National Construction Code Assessment Report

PROJECT: Mixed use Development - HOMEBUSH

LOCATION: 21 PARAMATTA ROAD,
HOMEBUSH
NSW, 2140

**REVISION
NUMBER:** 4

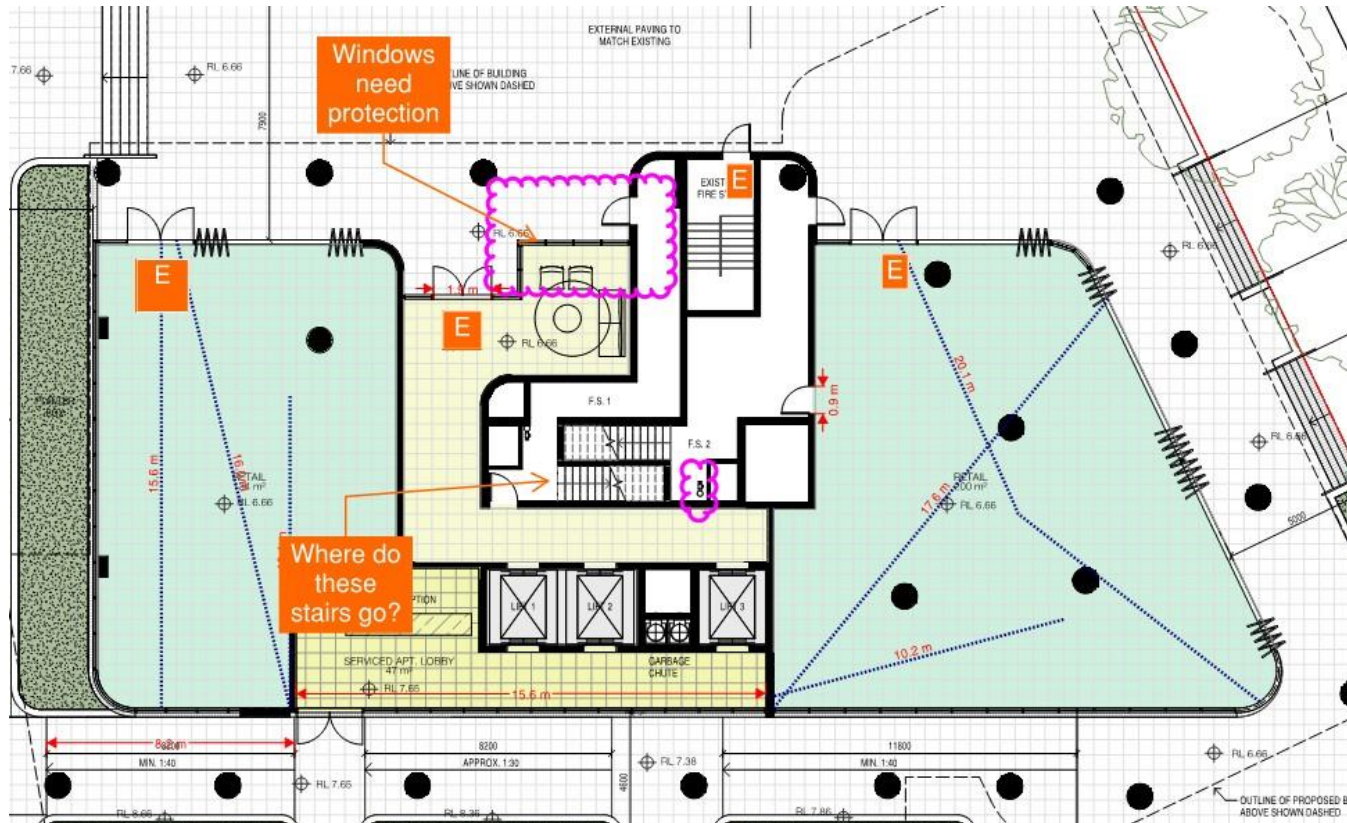
(Assessed BCA Report V.3 – see amended diagram V4)

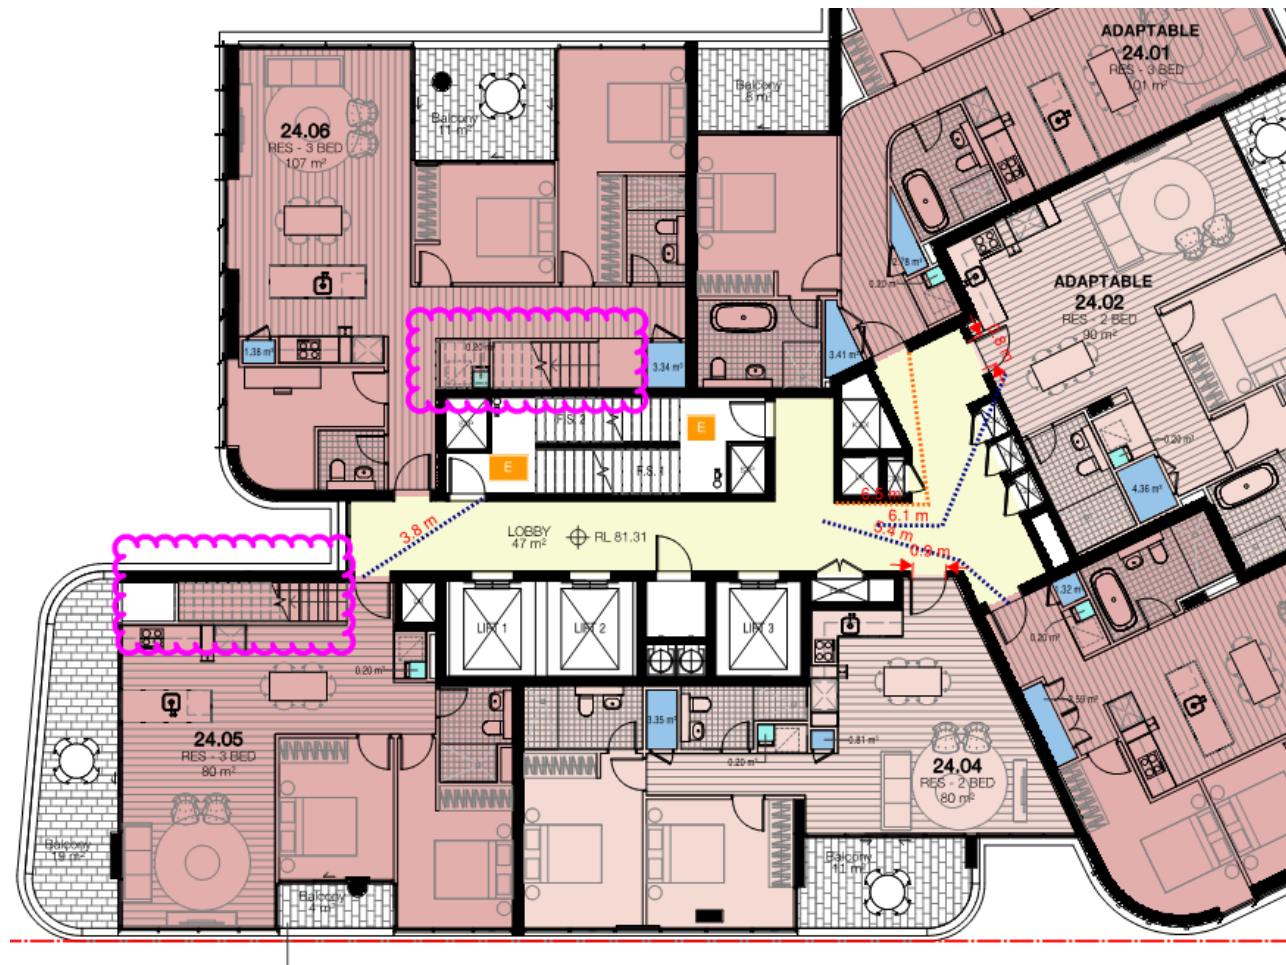
(Assessed BCA Report V.4) Amended L 23

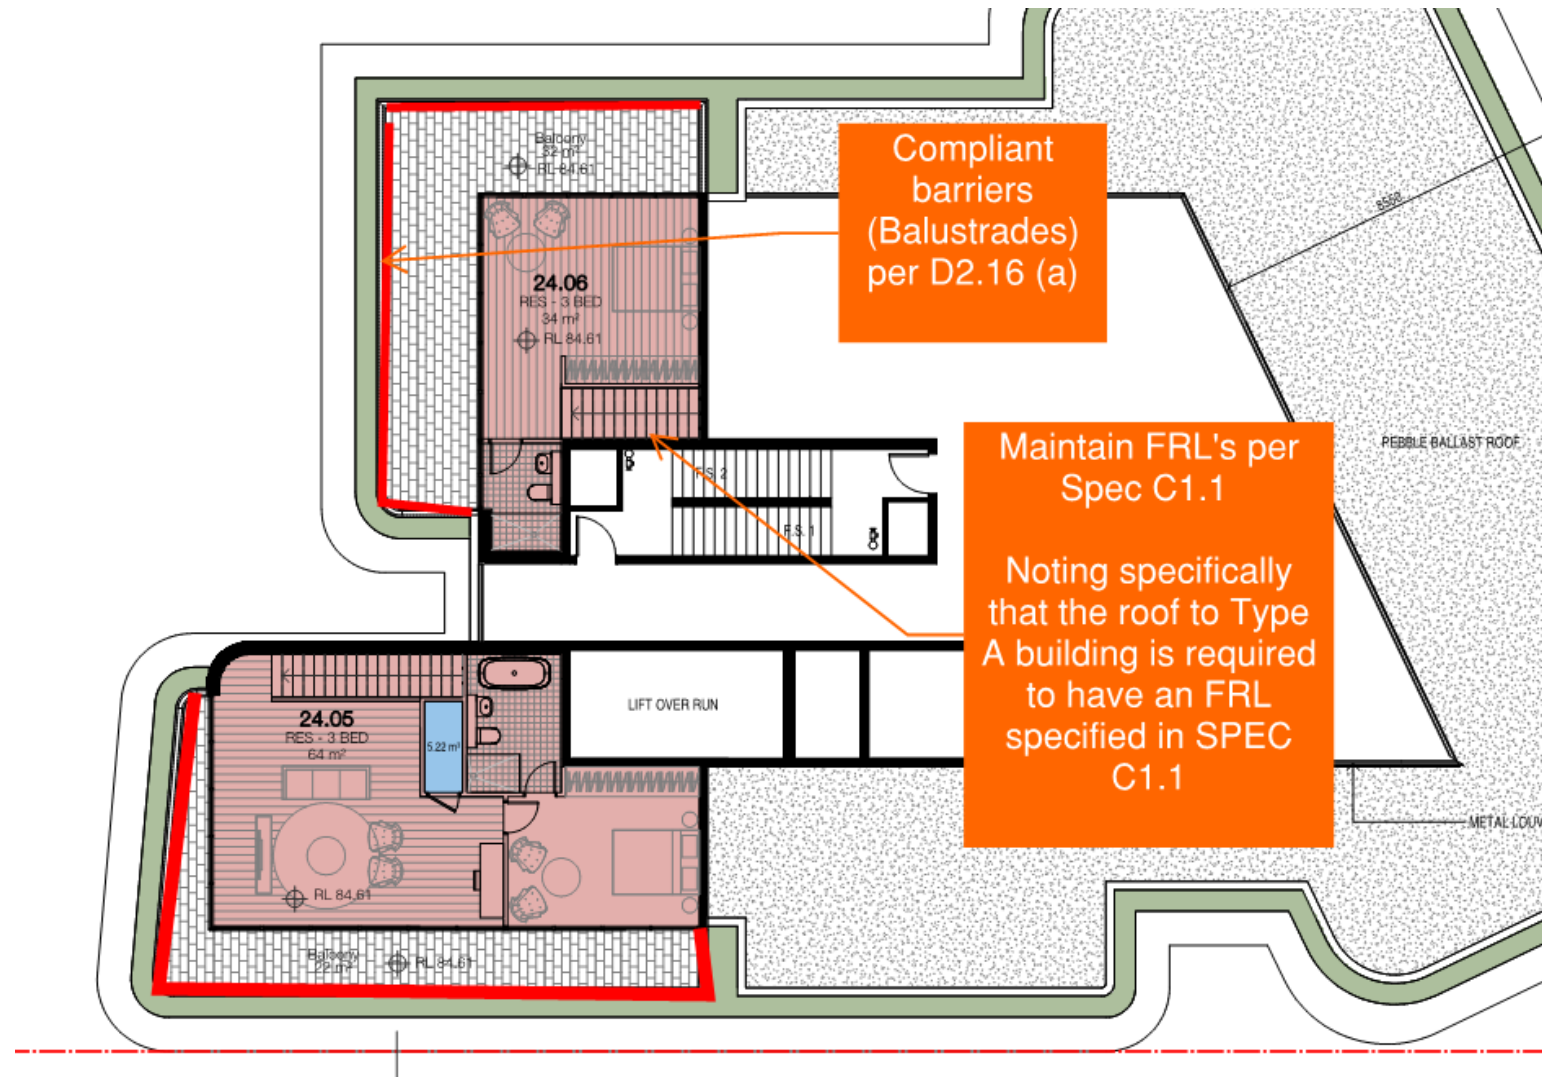
(Assessed BCA Report V.4) Amended L 24 - Roof

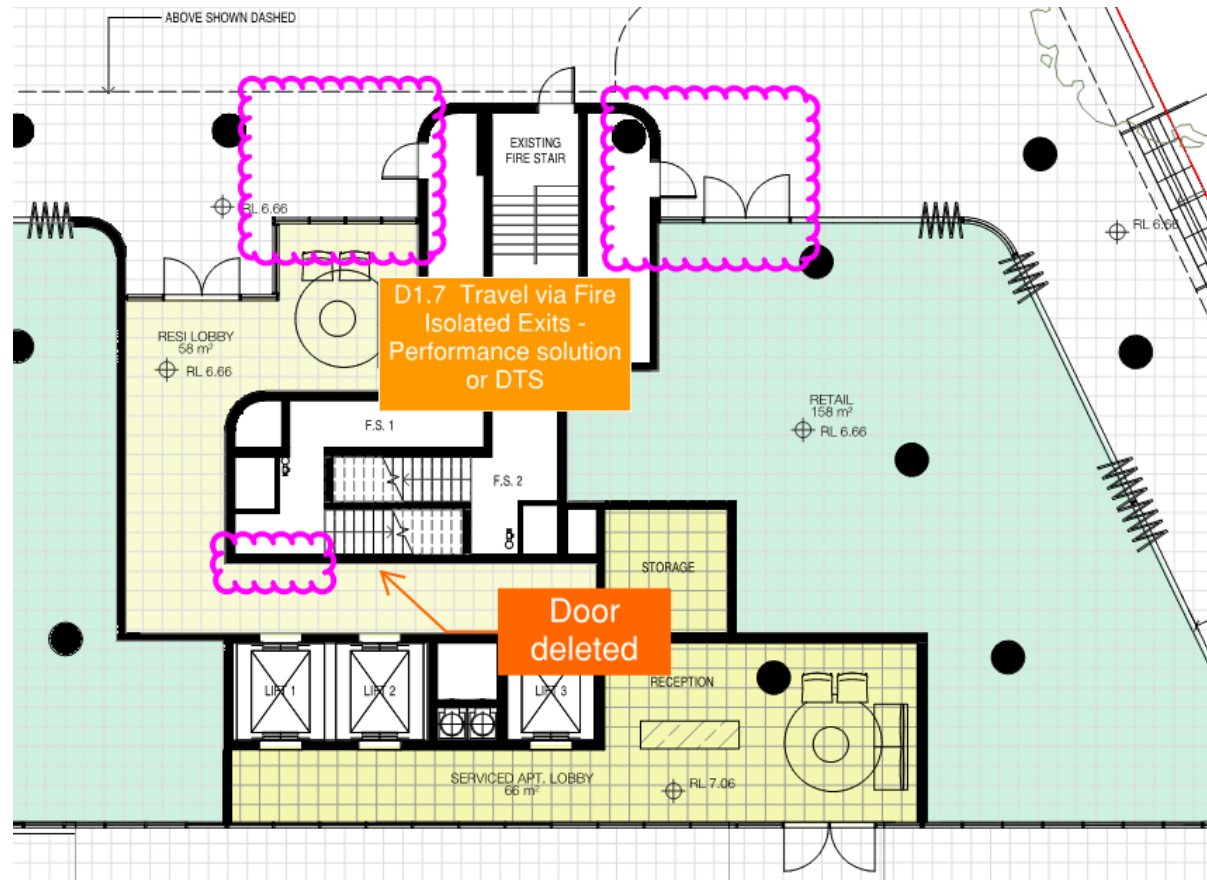
(Assessed BCA Report V.4) Amended Ground
